Department of Public Works
Engineering Division

May 07, 2024

CITY OF BERKELEY
FY 2023 RETAINING WALL AND STORM DRAIN IMPROVEMENT PROJECT
SPECIFICATION NOS. 23-11616-C & 23-11614-C (RE-ISSUED)
ADDENDUM NO. 2

1 STRUCTURAL DETAIL
SCALE: NTS

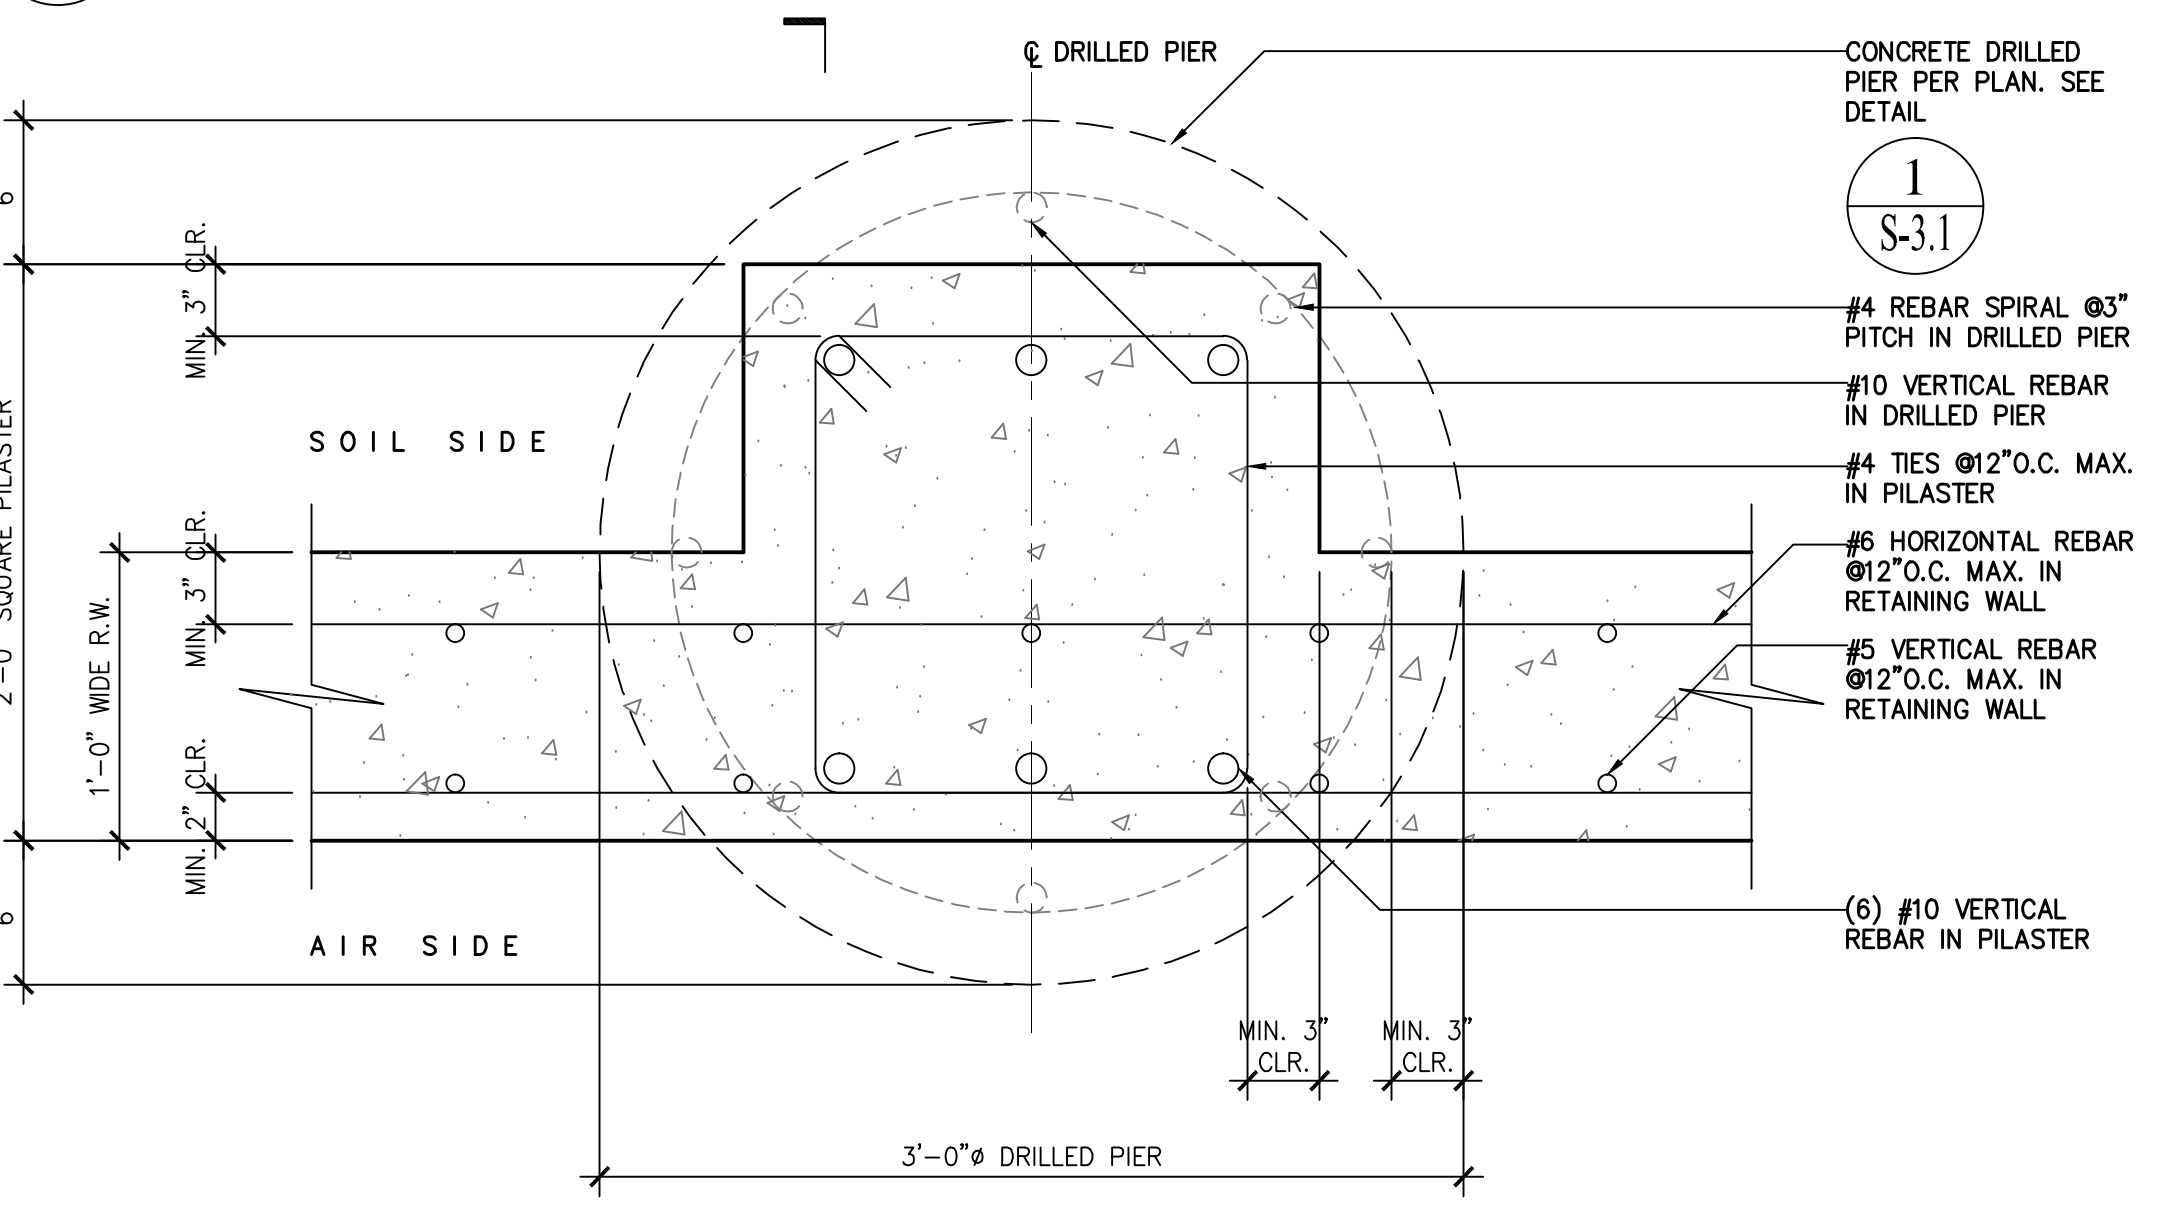
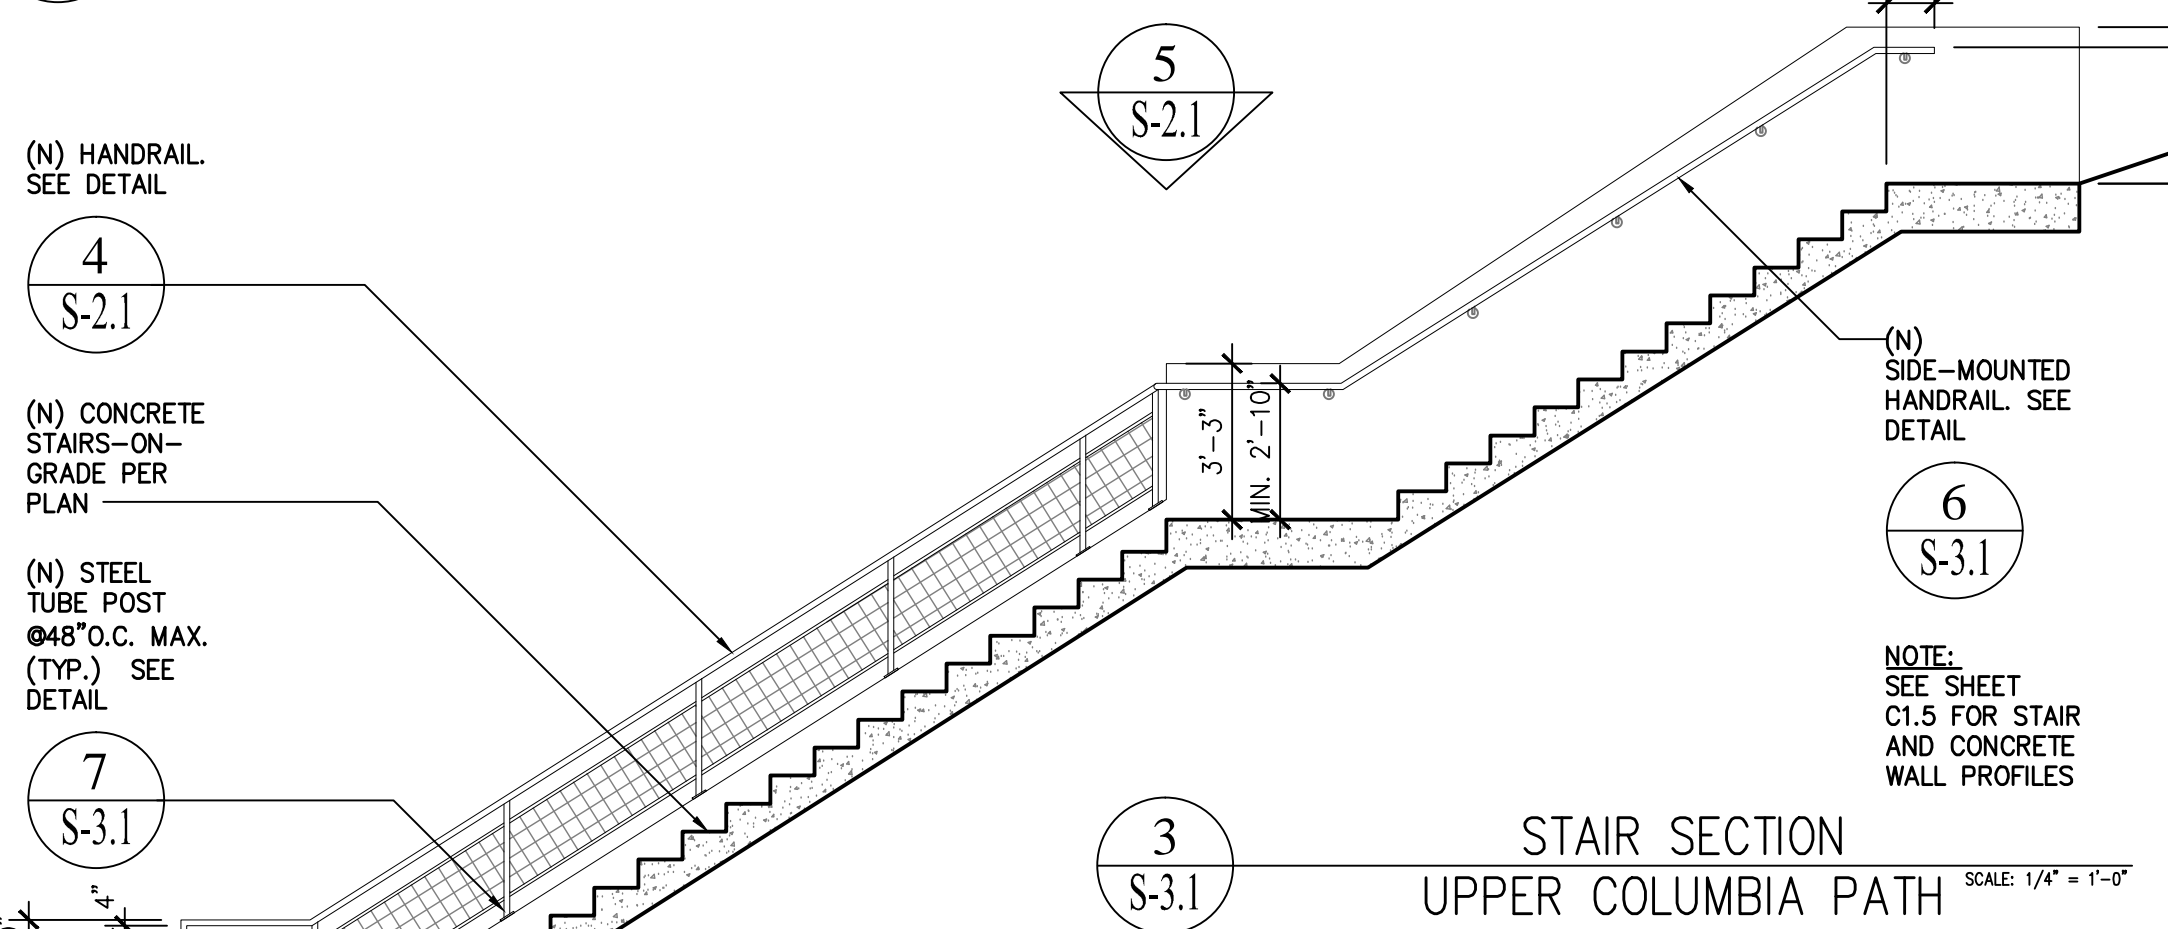
1. **Plans:** Package A, Drawing S-3.1
REPLACE with attached revised Drawings S-3.1.
Modified: Use (8) #10 Vertical Rebar – Detail#1 / Notes 4
Added : Depth of Piers, Depth = 30 Feet - Detail #4 , Notes 1
2. **Bidder's Proposal Page#13**
REPLACE with attached revised Bidder's Proposal – Page 13
The contractor shall complete all work specified in the contract documents in accordance with the plans and specifications within One Hundred Sixty (160) working days from the date established in the Notice to Proceed.
3. **Bidder's Specifications: Measurement & payment – Drilled Piers Page#TP-A-39**
REPLACE with attached revised "Drilled Pier" Measurement & Payment

4 PILASTER SECTION DETAIL
SCALE: 1" = 1'-0"

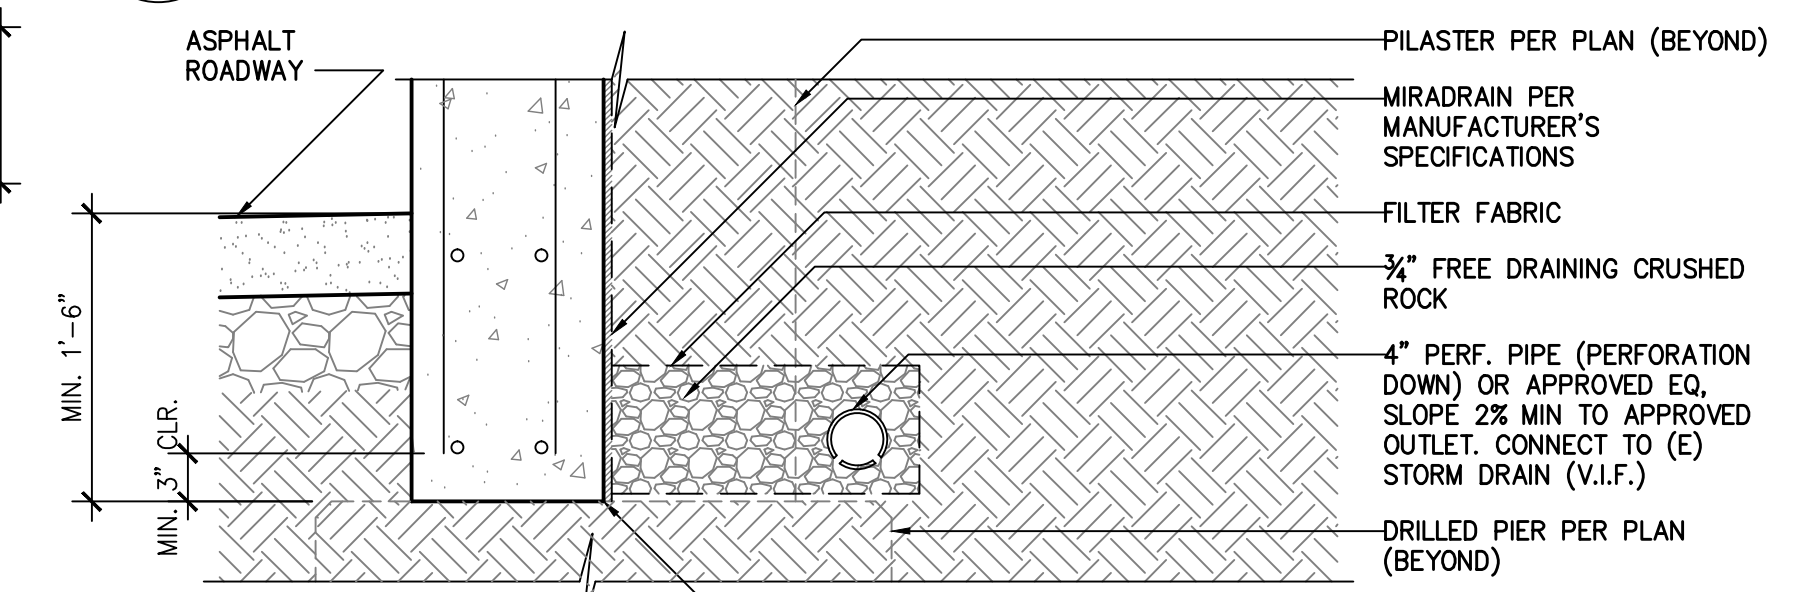
Question: How am I supposed to bid the drilled piers if the actual depths won't be determined until the bid is over and construction begins and when is the expected start date?

Response: Please see Detail 4/S-3.1 Notes 1; Depth of Piers = 30 Feet
Tentatively, it will take two to three months to execute the contract after the bid opening date. The city expects construction to start within one month of contract execution.
